Access Compliance Report

Public Rights-of-Way

(Curb Ramps)

Intersection ID: 24705	Main Street: CHOATE_CR	Cross Street: CINNAMON_FIELD_RD	Location: SW
ADA ID: 59E660E11C30	Ramp Type: Perp	Initial Pass/Fail: Fail	Overall Compliance: No
Severity Score: 37.5			
Codes/Mitigation Info/Possible Solution		Field Measurements/Component Compliance

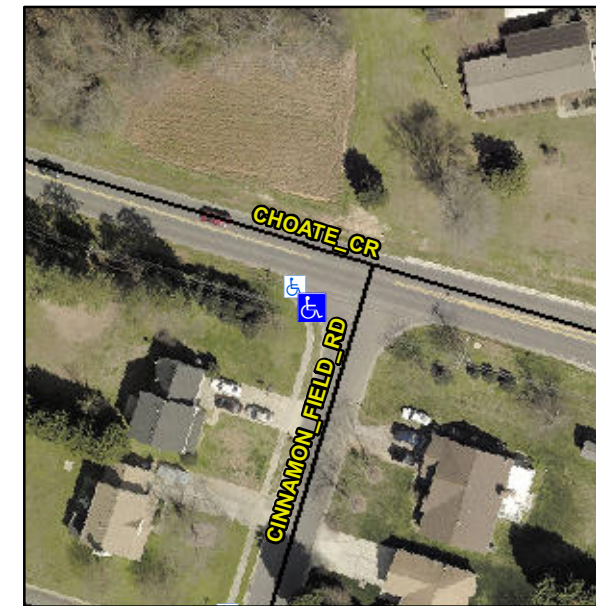
R304.2.2, R304.5.3

Compliance	Description	Data	Compliance	Description	Data
N/A	Ramp Length (in)	48.0	No	Ramp Slope (%)	9.0
Yes	Ramp Width (in)	64.0	No	Ramp XSlope (%)	7.5
N/A	Flare Type LT	N/A	N/A	Flare Type RT	N/A
N/A	Flare Slope LT (%)	N/A	N/A	Flare Slope RT (%)	N/A
N/A	Flare Traversable LT?	N/A	N/A	Flare Traversable RT?	N/A
N/A	Landing Length (in)	N/A	N/A	DWS Provided?	N/A
N/A	Landing Width (in)	N/A	N/A	DWS Contrast?	N/A
N/A	Landing Slope (%)	N/A	N/A	DWS Length (in)	N/A
N/A	Landing X Slope (%)	N/A	N/A	DWS Full Width?	N/A
N/A	Landing Curb? (Y/N)	N/A	N/A	DWS Offset (in)	N/A
N/A	Shared Landing?	N/A			
N/A	Gutter Ponding?	N/A	N/A	Gutter Slope (%)	N/A
N/A	Gutter Lip Ht (in)	N/A	N/A	Gutter X Slope (%)	N/A
N/A	Painted X Walk1?	No	N/A	Painted X Walk2?	N/A
	X Walk 1 Direction	To SE		X Walk 2 Direction	N/A
N/A	X Walk 1 Width (in)	N/A	N/A	X Walk 2 Width (in)	N/A
	X Walk 1 Slope (%)	1.9		X Walk 2 Slope (%)	N/A
	X Walk 1 X Slope (%)	5.3		X Walk 2 X Slope (%)	N/A

Remove & Replace Entire Ramp.
